UNITED STATES PATENT AND TRADEMARK OFFICE

APPLICATION NO.	FILING DATE	FIRST NAMED INVENTOR	ATTORNEY DOCKET NO.	CONFIRMATION NO.
10/524,185	10/11/2005	Kerry D Hinson	60680-2004	2663
10291	7590	07/27/2006		
RADER, FISHMAN & GRAUER PLLC 39533 WOODWARD AVENUE SUITE 140 BLOOMFIELD HILLS, MI 48304-0610			EXAMINER ESHETE, ZELALEM	
			ART UNIT 3748	PAPER NUMBER

Office Action Summary

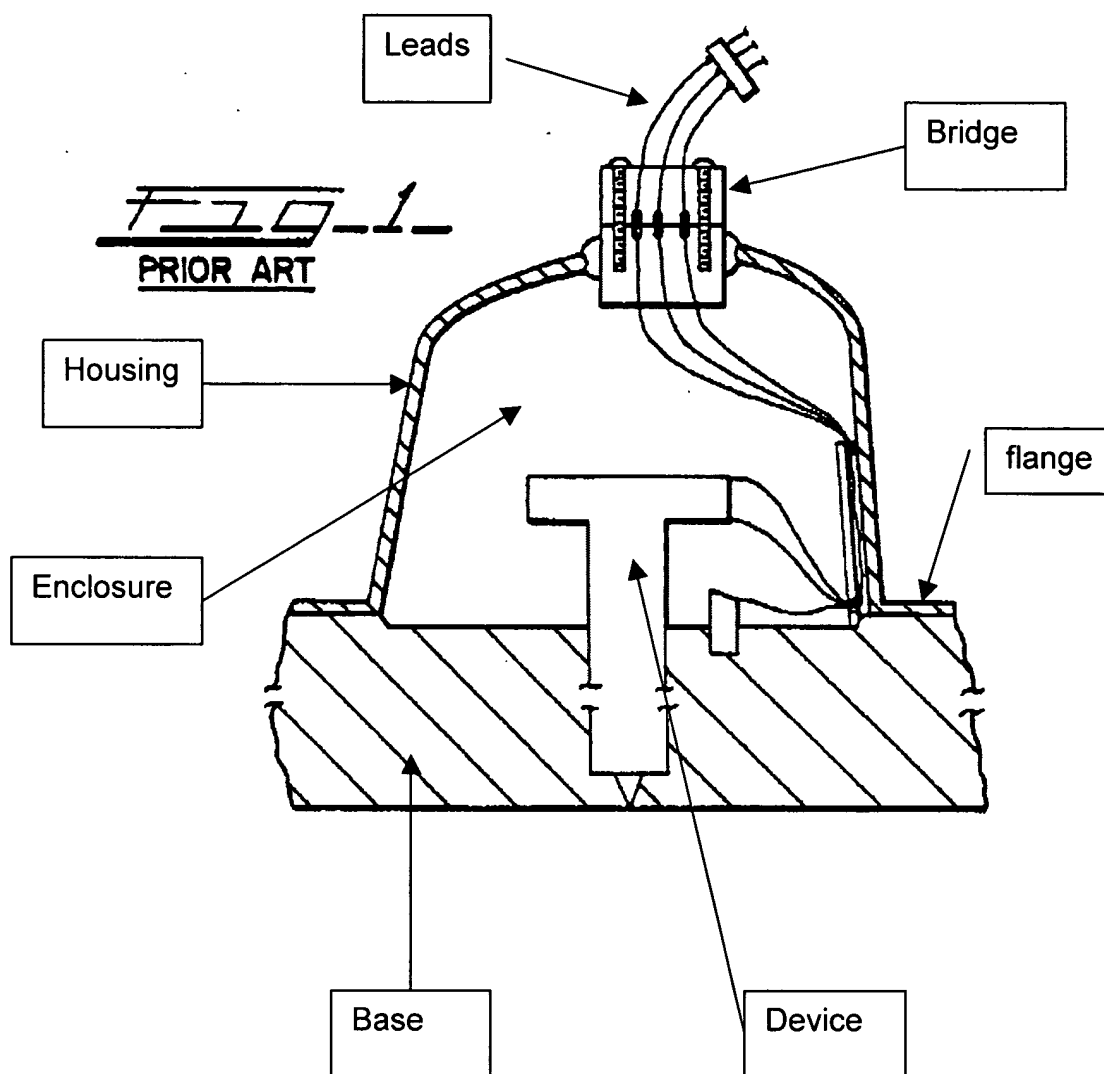
Regarding claims 1,3: Mathew discloses a cover with an electrical bridge comprising a base component; a housing mounted to the base component defining an enclosure therein; at least one electrical connector integrally formed with the housing, the at least one electrical connector including one or more electrical leads that extend through the housing for allowing electrical energy to pass from an electrical source

outside the housing to an electrical device within the enclosure, thereby forming an electrical bridge between the electrical source and the electrical device wherein “the electrical bridge does not extend along an exposed surface of the housing” (see labeled figure below).

Regarding claim 7: Mathew as modified above discloses the housing comprises a bottom "pan" flange (see labeled figure above).
